Arizona Electric Power Cooperative, Inc.

**RE: AEPCO RESPONSE TO EPA SITE ASSESSMENT REPORT
RECOMMENDATIONS**

Specific Site Assessment for Coal Combustion Waste Impoundments
Arizona Electric Power Cooperative (AEPCO) Apache Power Plant
Cochise, AZ
December 2009

Piezometer Locations

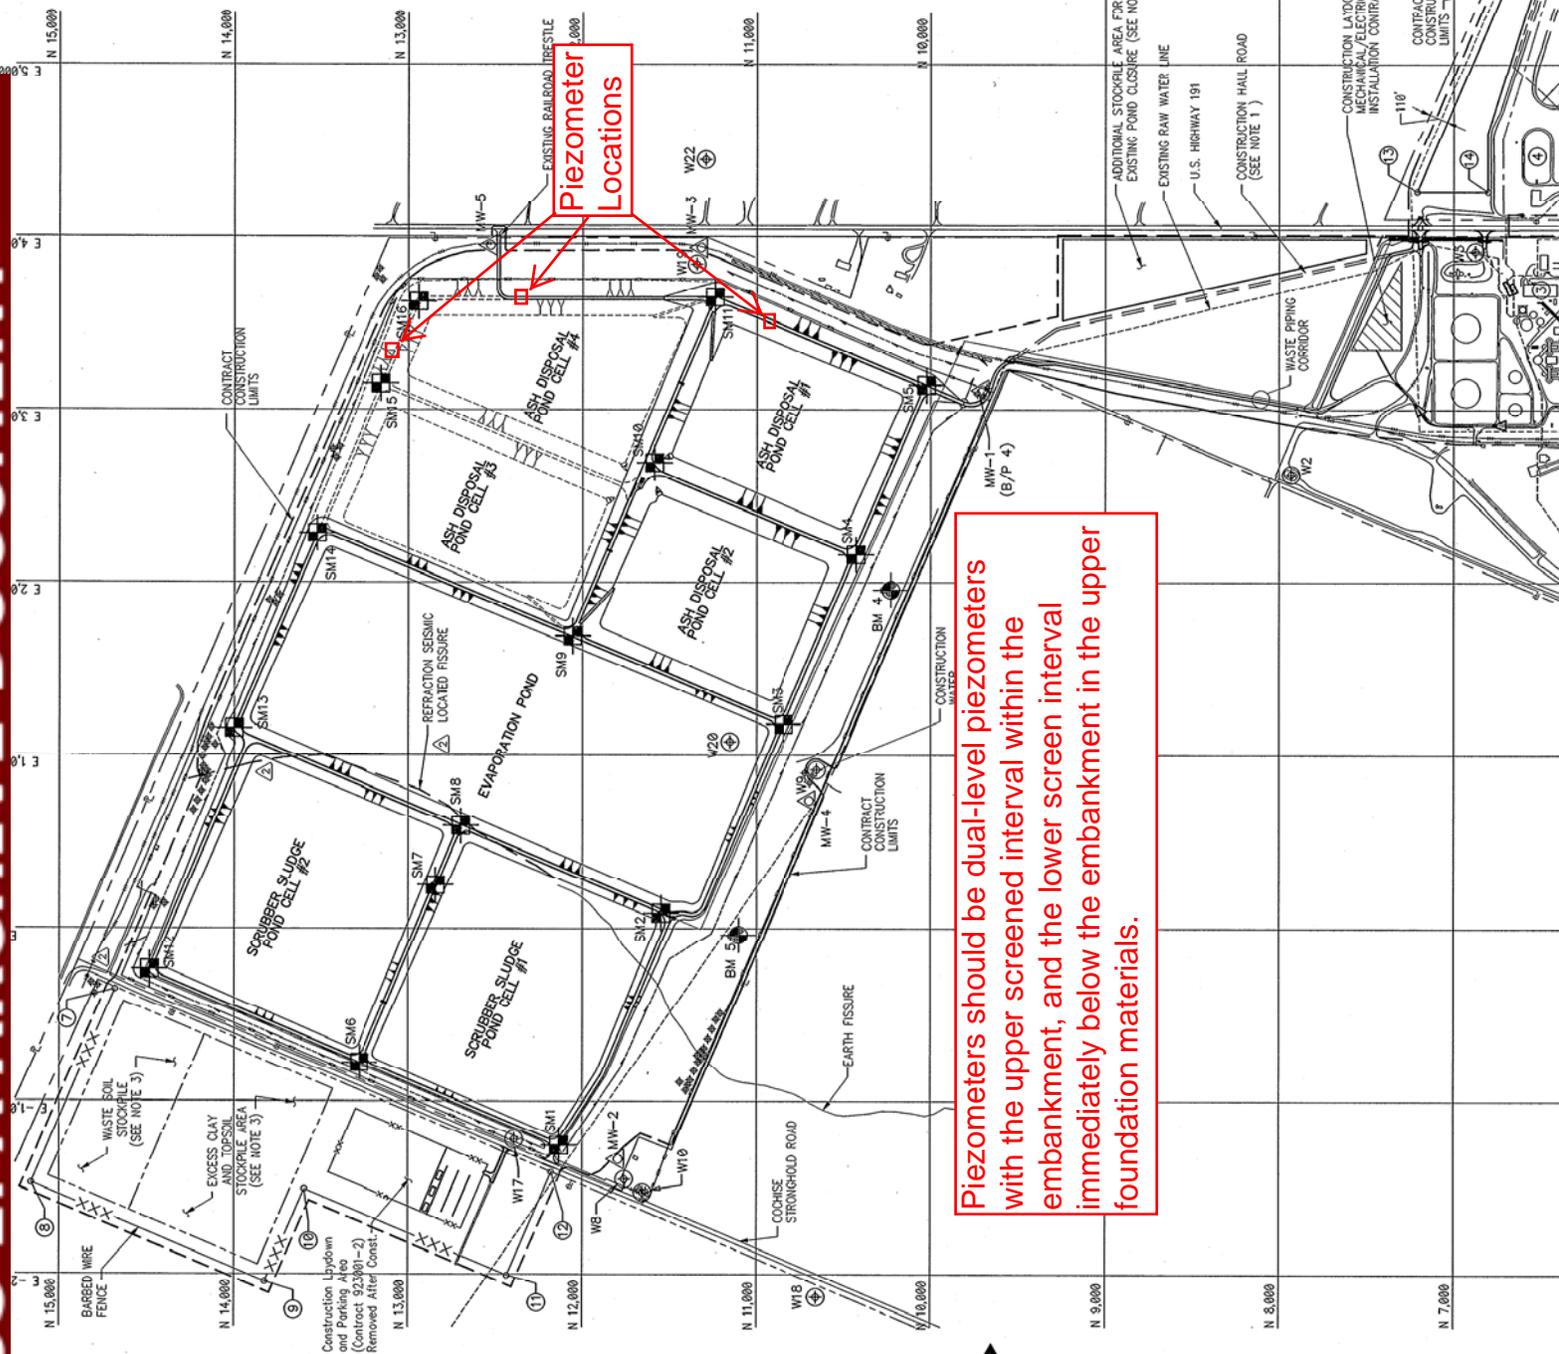
It was good speaking with you and Jim last week. In response to your questions on how many/where the piezometers should be installed, I've attached some guidance and a map. I understand that AEPCO has shallow wells immediately down gradient of the impoundments and you haven't had any liner problems in past. However, installing piezometers from the dam crest would deal with the stability issues (vs. the leakage issues) we are concerned about. Please let Steve or myself know if you have any questions. Thank you-

Piezometers should be dual-level piezometers with the upper screened interval within the embankment, and the lower screen interval immediately below the embankment in the upper foundation materials.

AEPCO is in agreement that piezometers will be installed in locations as depicted on the map provided by your office in a March 17, 2010 email. After internal discussions, AEPCO has some questions related to the actions of installing piezometers.
